County of Santa Clara
Department of Planning and Development

DATE: December 16, 2020
TO: Airport Land Use Commission
FROM: Mark Connolly, Senior Planner / Deputy Zoning Administrator
SUBJECT: City of San Jose General Plan Amendment and Rezoning for the Downtown West project

Consider recommendations relating to a request from the City of San Jose for a General Plan Amendment and Rezoning for the Downtown West Project, within the Airport Influence Area of San Jose International Airport (SJC). (City of San Jose Planning File Nos. GP19-009, PDC19-039-multiple parcels)

Figure 2
Existing General Plan Land Use Designations

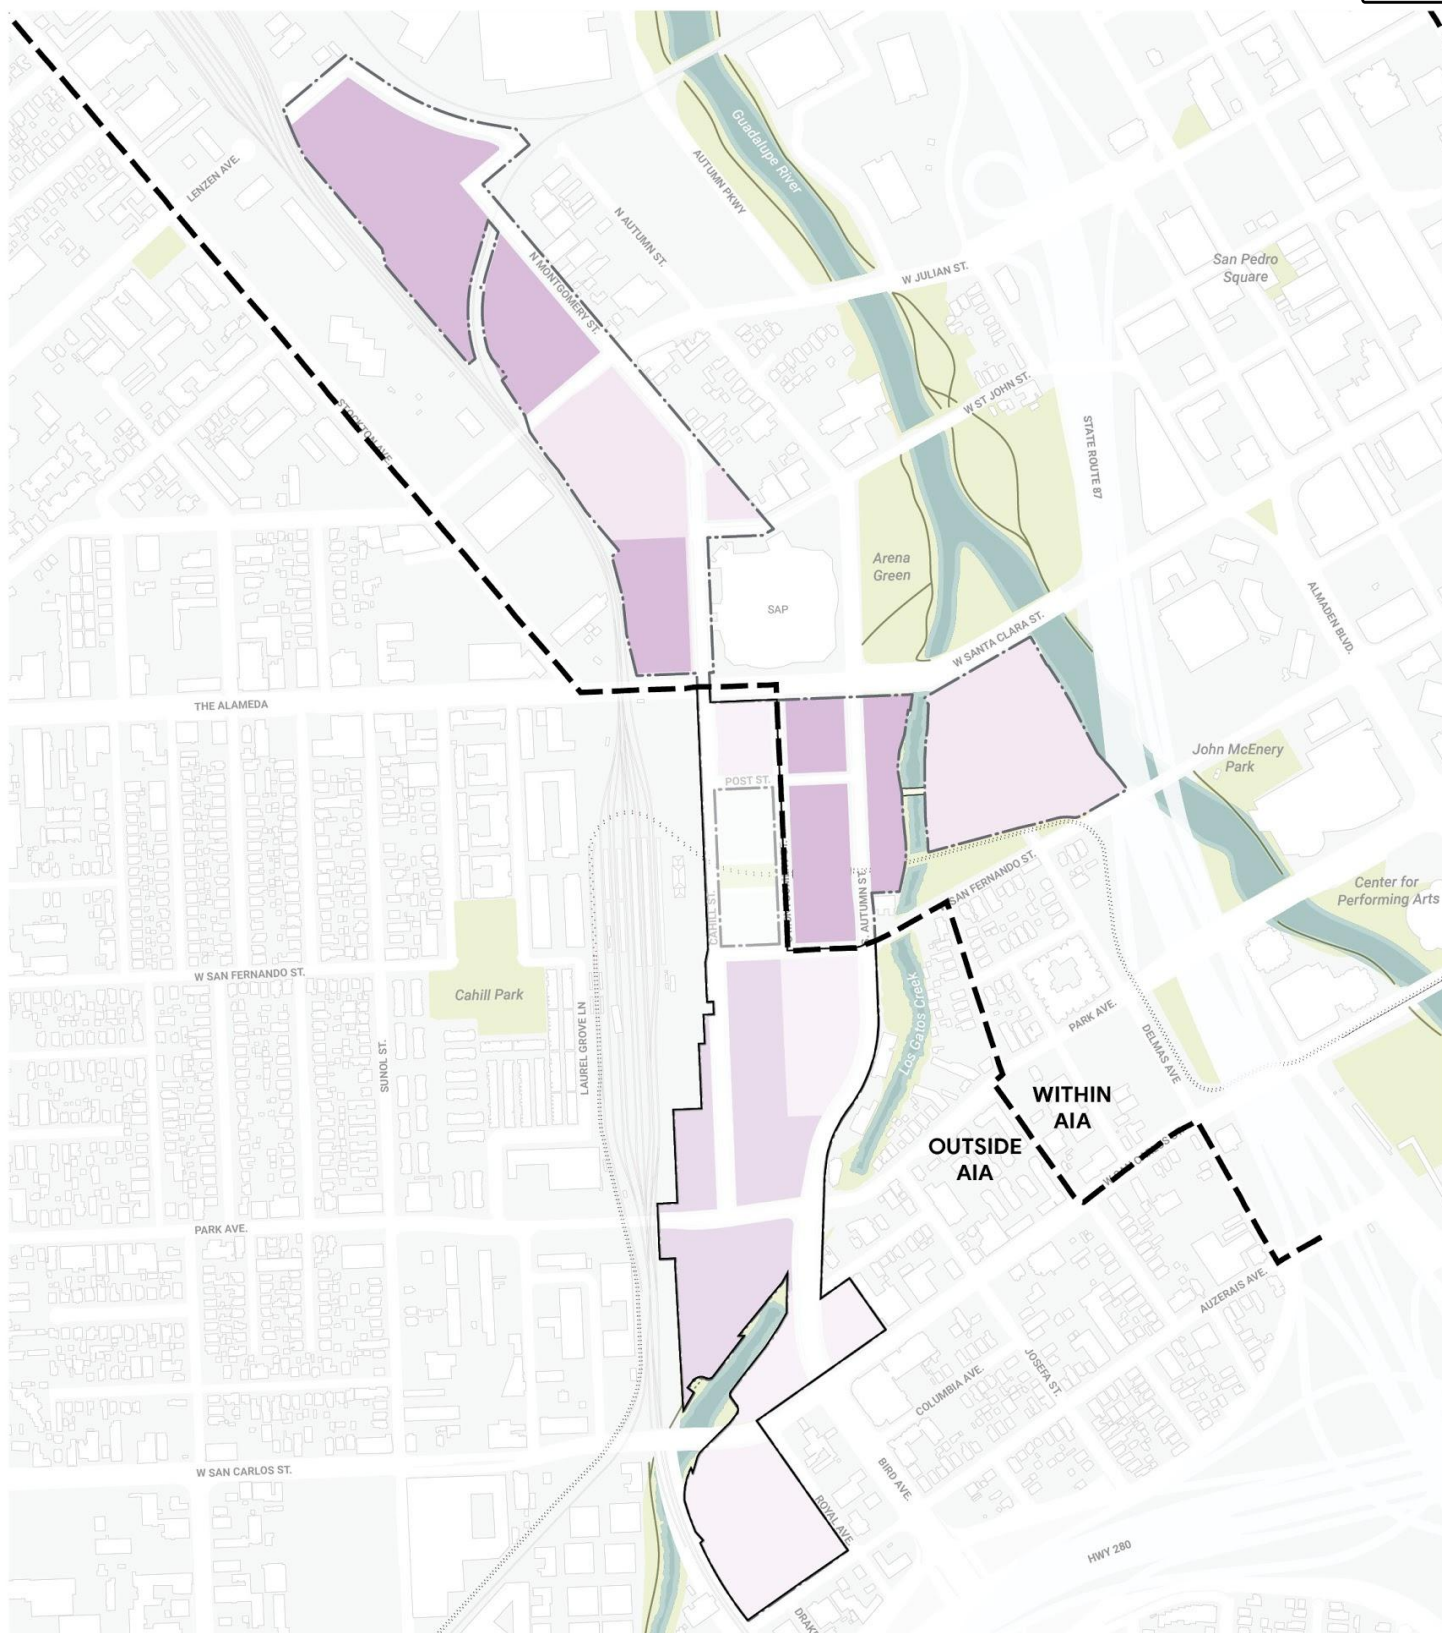
As can be seen on Figures 2 and 3 of the referral, the General Plan Amendment of the project entails amending the existing General Plan designations of Transit Employment Center, Public / Quasi Public, Downtown, Commercial Downtown and Open Space to Downtown and Commercial Downtown, to allow for the mixed commercial, office, retail and residential development proposed in the plan.

Fig. 2 Existing General Plan Designations shows the existing land use designations under the San José General Plan 2040. The existing designations only allow residential uses on one Project block within the AIA, designated as Downtown.

Figure 3
Proposed General Plan Land Use Designations

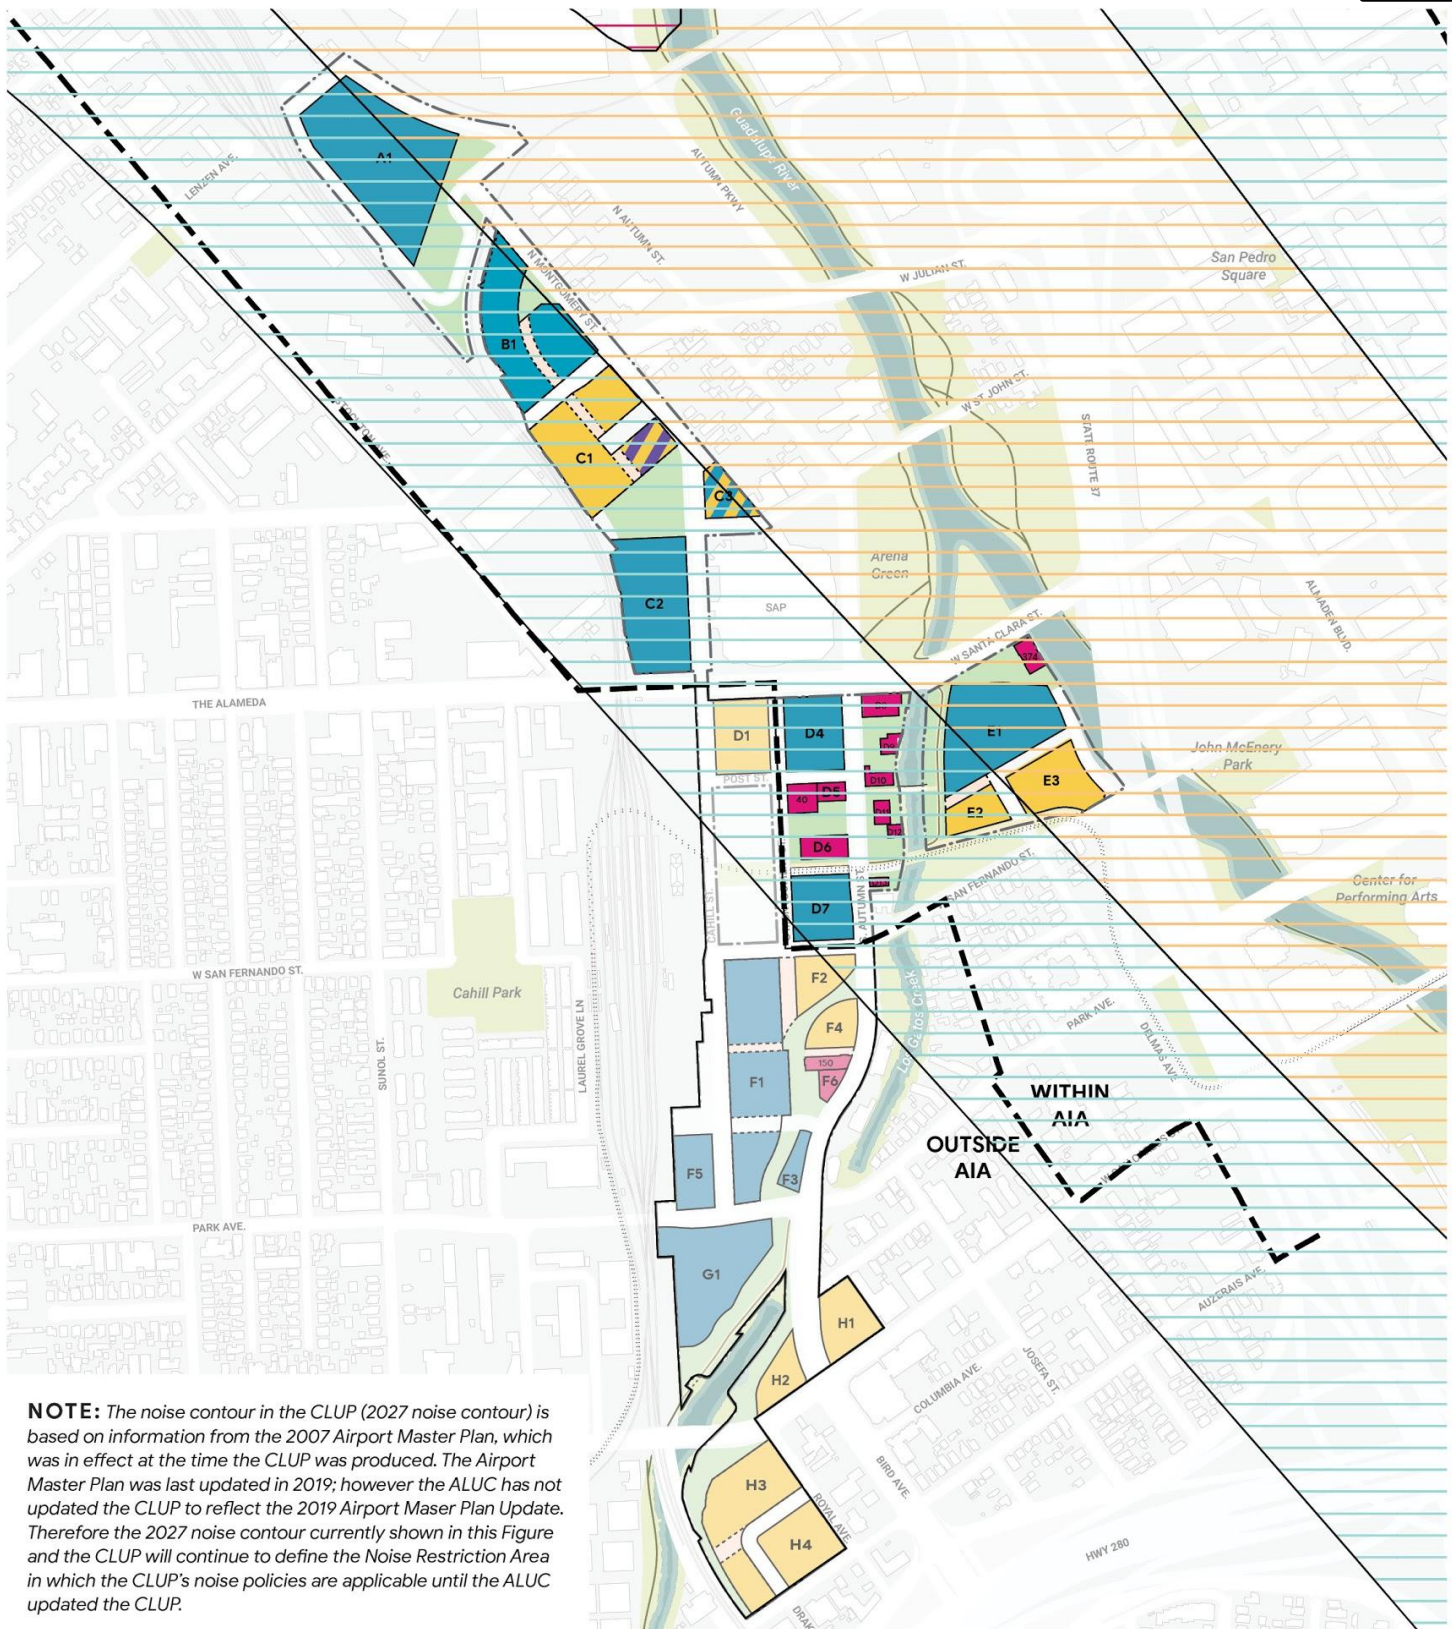
Fig. 3 Proposed General Plan Designations the City and Project propose to redesignate the area to a mix of Downtown and Downtown Commercial, in order to deliver a mix of uses. Because the Downtown designation allows residential uses, the land use redesignation will increase the areas in which residential uses are permitted.

Figure 4
Noise Contours 2027 Forecast (dBA CNEL)

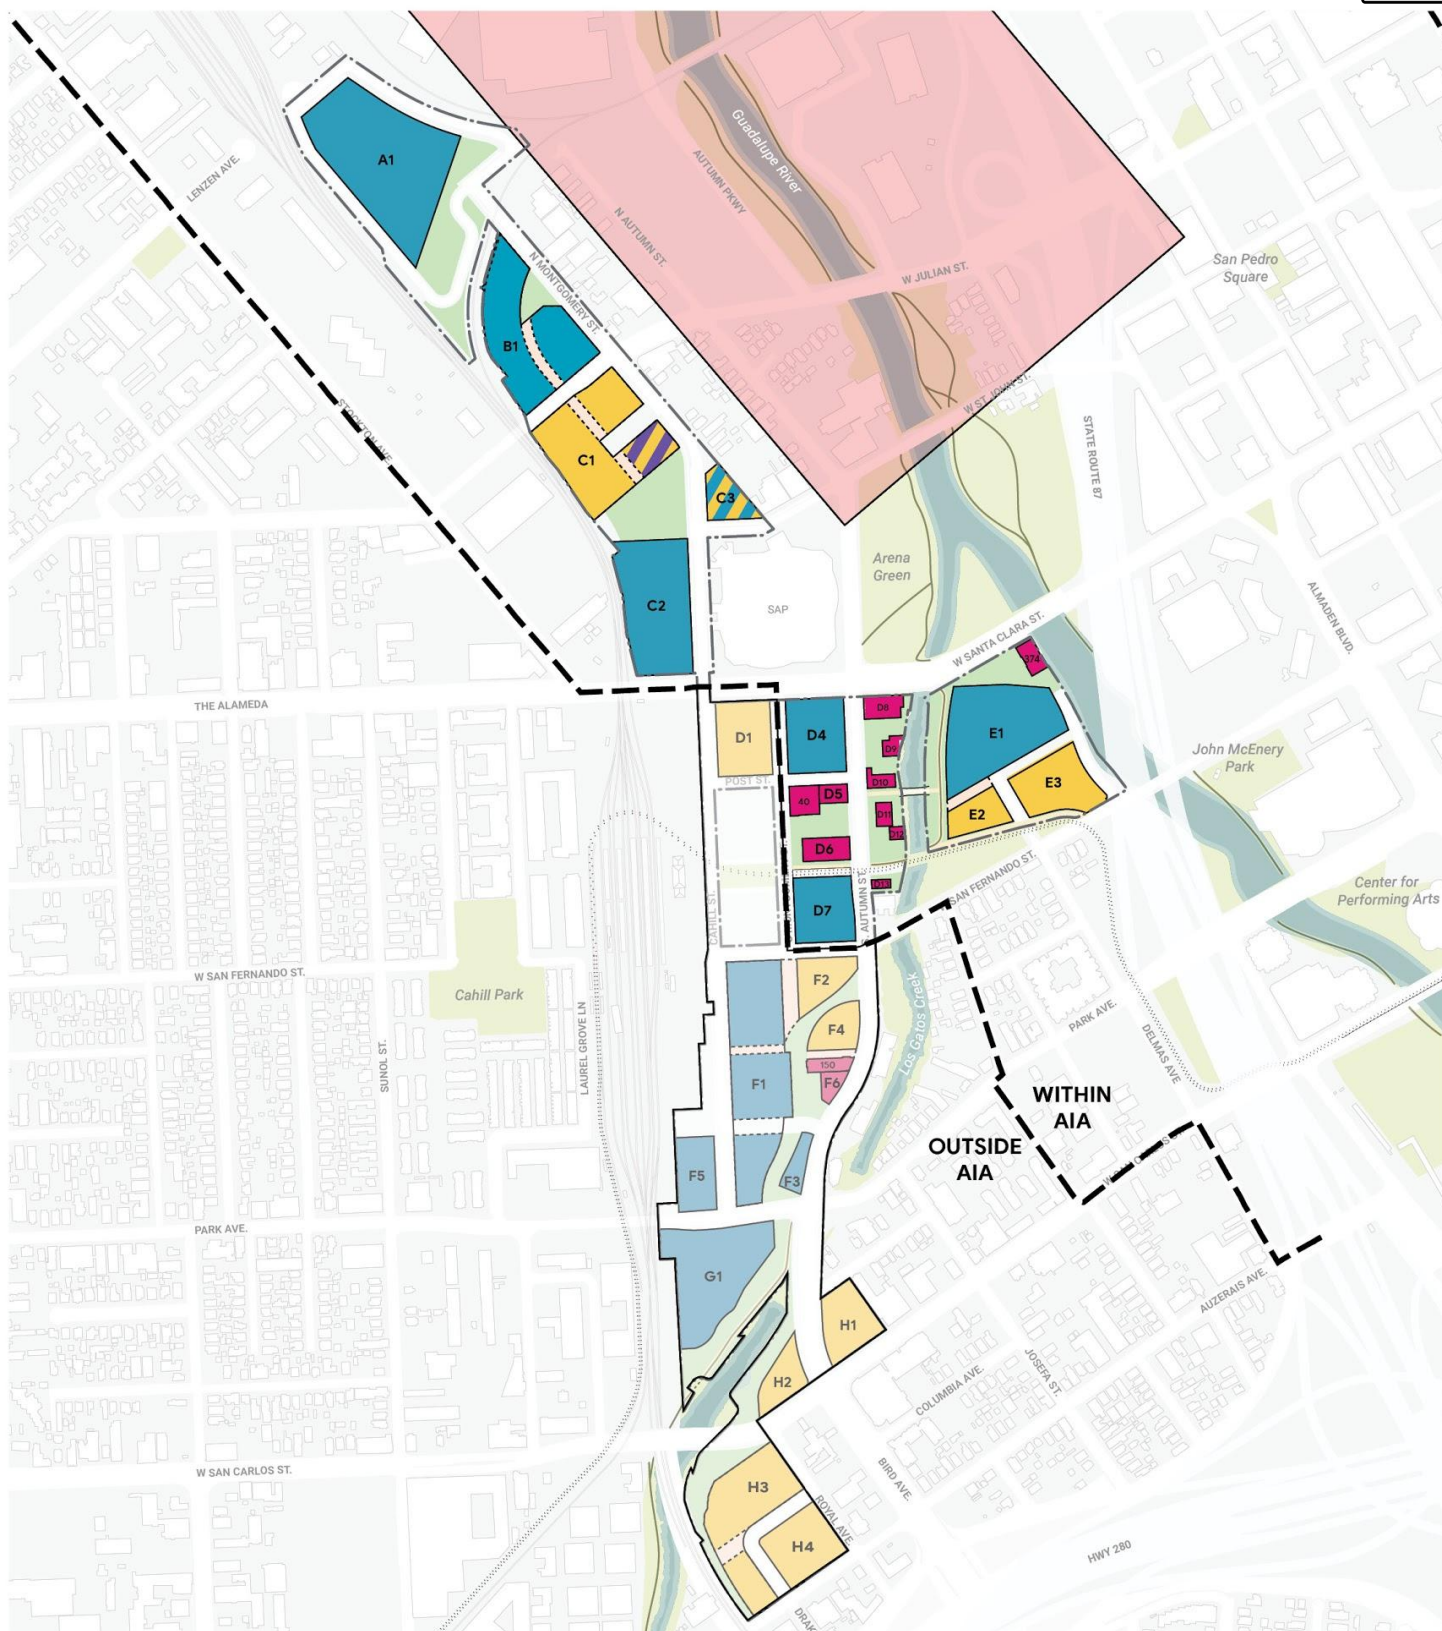
As can be seen on Figure 4 “Noise Contours 2027 forecast”, the project area is between the 60 and 65 dBA CNEL noise contours. The General Plan Amendment would allow Employment Commercial, residential and retail uses within both CNEL noise contours.

Fig. 4 Noise Contours 2027 Forecast overlays the CLUP noise contours with the proposed Project land use plan. A portion of the site is within the 65 dBA CNEL contour boundary. Mitigation Measure NO-3, proposed to be adopted as part of the Project’s Mitigation Monitoring and Reporting Program, would require preparation of a noise reduction plan to ensure that residential and hotel buildings subject to such noise levels would be designed with noise reduction measures so that interior noise levels would not exceed 45 dBA CNEL. All residential development may include outdoor balconies/patios.

Figure 6
Existing Heights: West OEI Corridor Heights

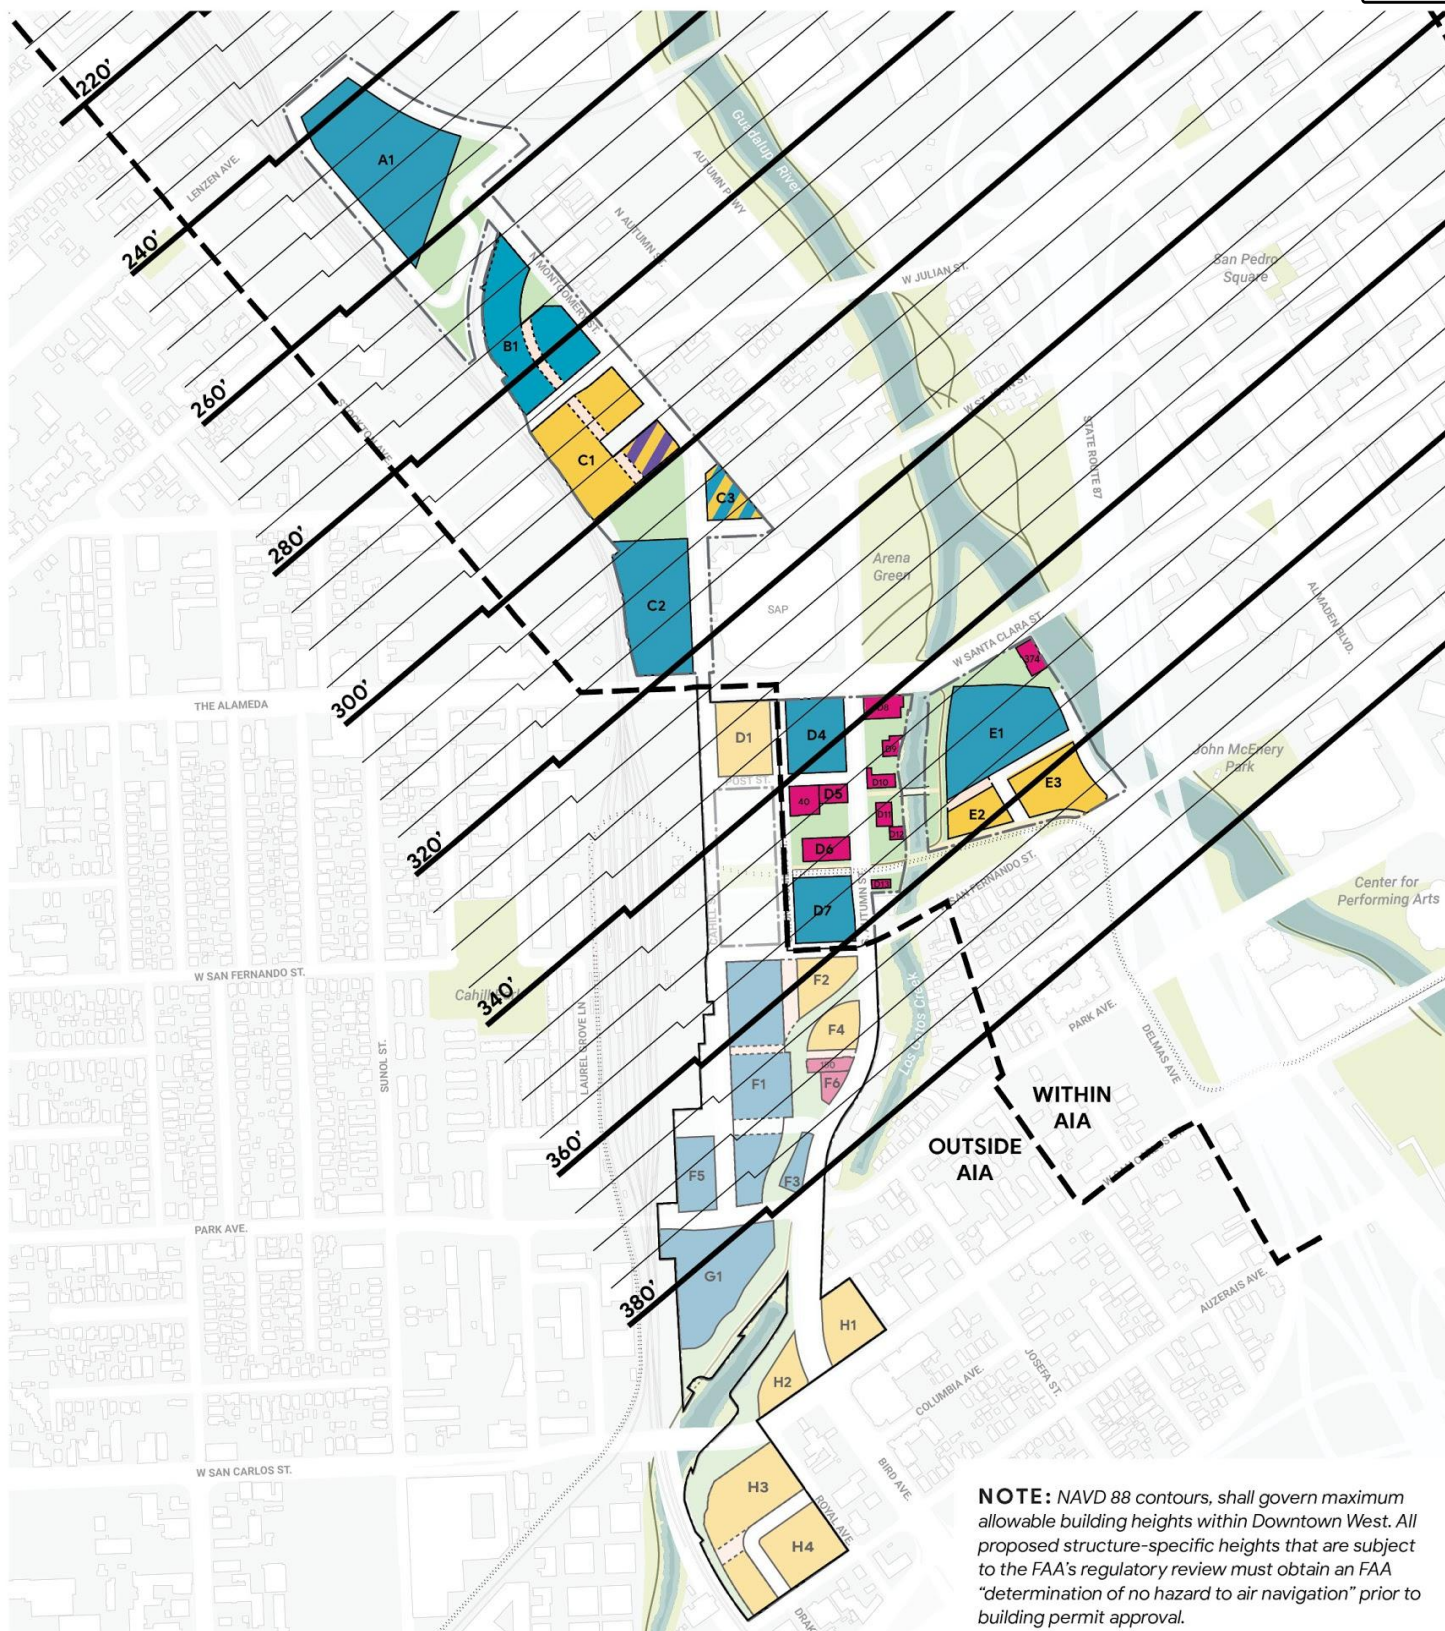
Figure 6 of the referral shows “existing heights / OEI”, but is actually the FAA FAR Part 77 surfaces. Figure 7 shows the Terminal Instrument Procedures (TERPS) surfaces. And Figure 7 shows the ground elevations. In June of 2020, the San Jose City Council adopted TERPS as the height limitation surfaces for the area south of SJC.

Fig. 6 Existing Heights: West OEI Corridor Heights reflect the existing height contours. On March 12, 2019, the City of San José City Council accepted the completed Downtown Airspace and Development Capacity Study, selecting Scenario 4, which would affirm the City’s development policy to use FAA Terminal Instrument Procedures (TERPS) surfaces in lieu of the One-Engine Inoperative (OEI) surfaces to determine maximum building heights in the Downtown Core and Diridon Station planning areas.
